IIoT Product End-of-Life Notice

End of Life, Last Time Buy and Replacement Announcement

For immediately release, Advantech is announcing the End of Life (EOL) of (IMC-370I-B series). The relative replacing models are as below list. Customers who had purchased this Part Number either to purchase any additional rules or migrate to the new replacement models if possible before the EOL's shipment date.

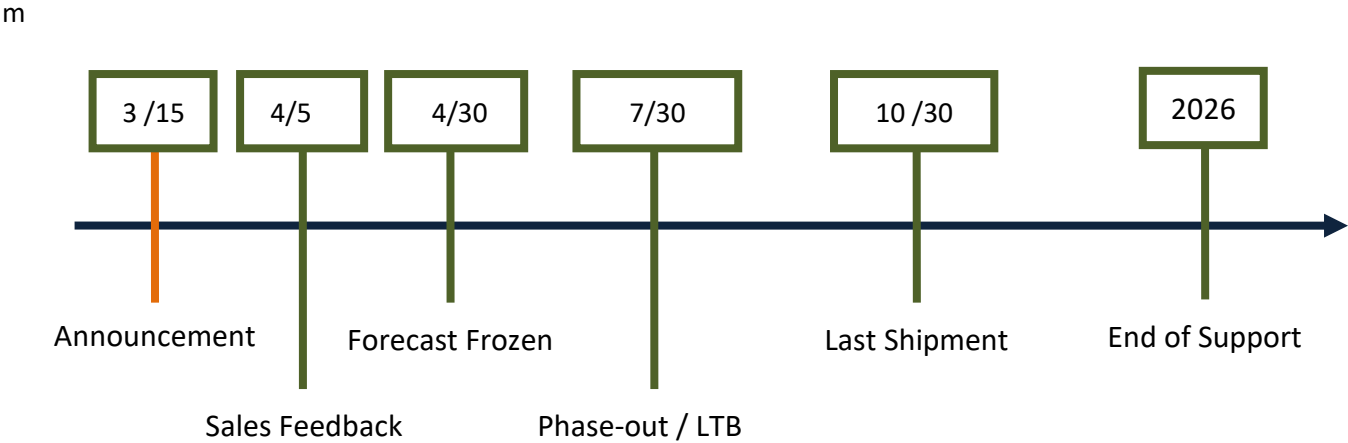
- Use better lead-time IC solution, Improve lead-time
- Addition PD function to make IMC-370I's function set is identical with IMC-350I series
- Addition Gigabit Fiber Optic Links support Auto mode and Force mode. (B version support Auto mode only)

End of Life Product	Suggest Replacement Product	Sample Available Date
IMC-370I-MM-B	IMC-370I-MM-C	2024/5/15
IMC-370I-SM-B	IMC-370I-SM-C	2024/5/15
IMC-370I-SFP-B	IMC-370I-SFP-C	2024/5/15
IMC-370I-SE-B	IMC-370I-SE-C	2024/5/15
IMC-370I-SSR-B	IMC-370I-SSR-C	2024/5/15
IMC-370I-SST-B	IMC-370I-SST-C	2024/5/15
